ADDENDUM NO. 1 TO PROJECT NO. 47294

CONSTRUCTION AND HVAC WORK
PROVIDE ISOLATION & CONTROL VALVES
SHERIDAN AVENUE STEAM PLANT
79 SHERIDAN AVENUE
ALBANY, NY

June 23, 2025

1 MEP SUPPORT FRAMING PLAN ABOVE STEAM BOILERS

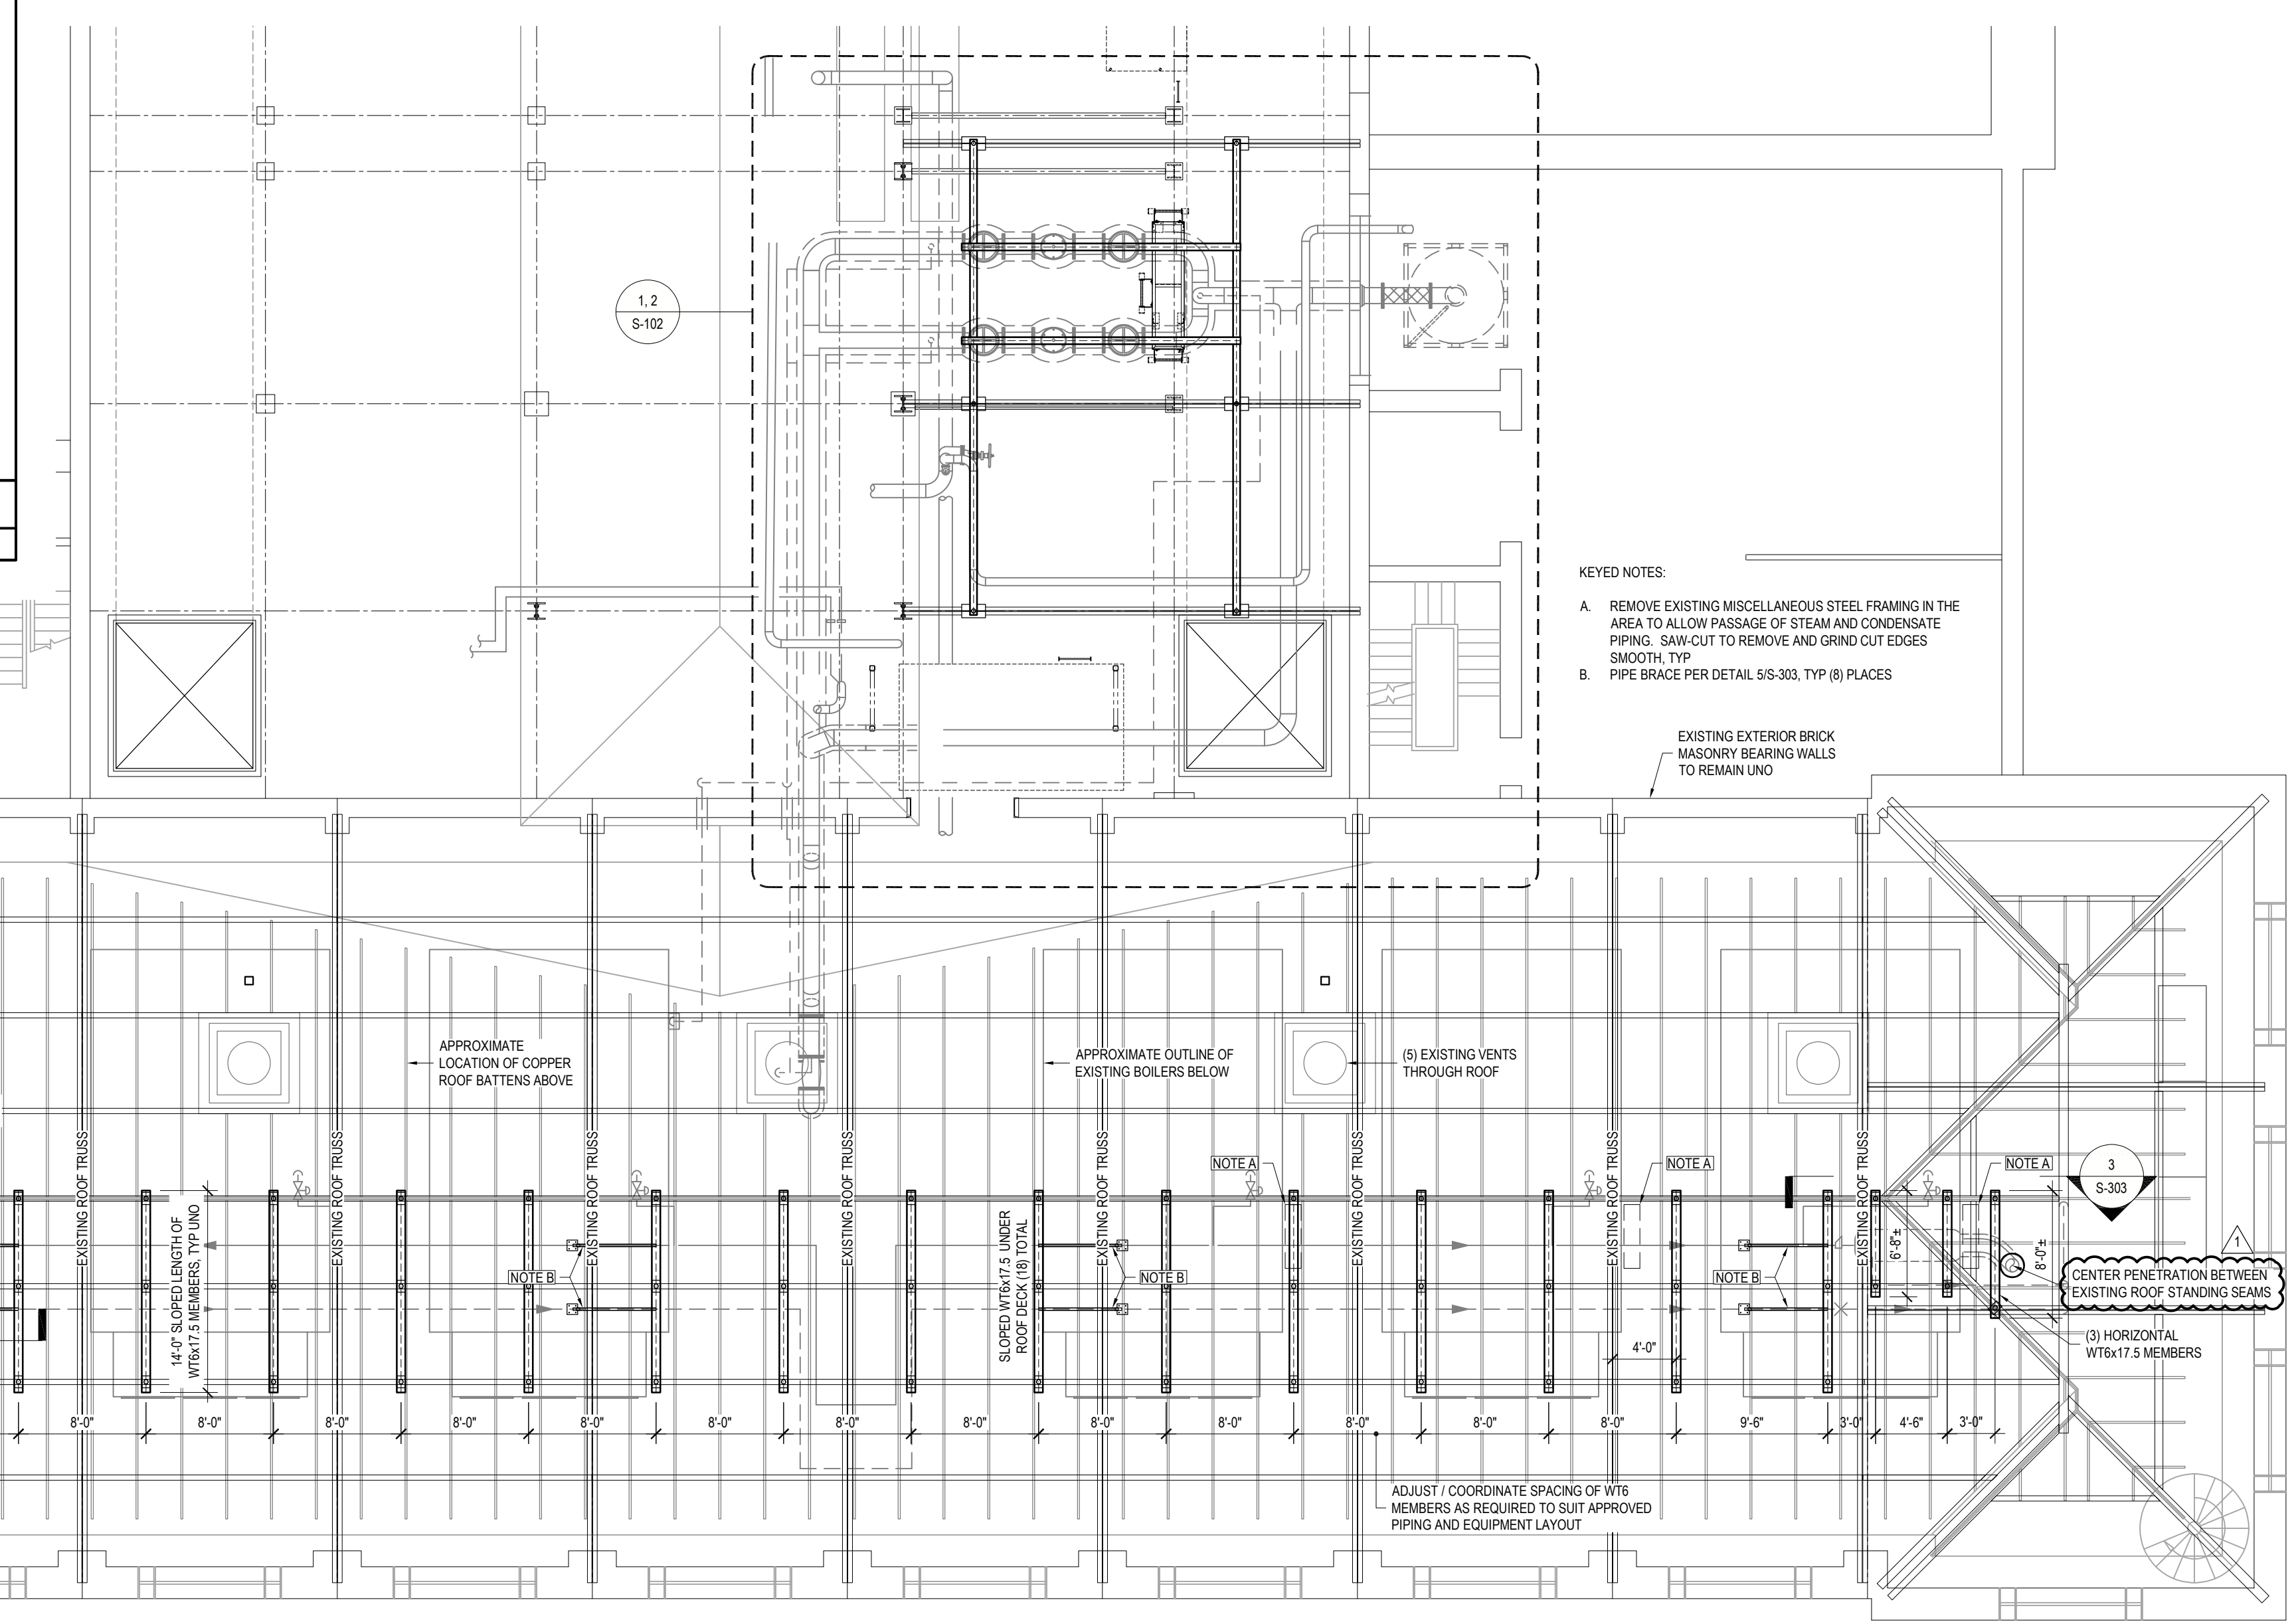
2. Revised Drawings:
 - a. Drawing Nos. S-101 and S-303, noted “ADDENDUM 1, 06/23/2025” accompany this Addendum and supersede the same numbered originally issued drawings.

- KEYED NOTES:
- A. REMOVE EXISTING MISCELLANEOUS STEEL FRAMING IN THE AREA TO ALLOW PASSAGE OF STEAM AND CONDENSATE PIPING. SAW-CUT TO REMOVE AND GRIND CUT EDGES SMOOTH, TYP.
 - B. PIPE BRACE PER DETAIL S-S-303, TYP. (B) PLACES
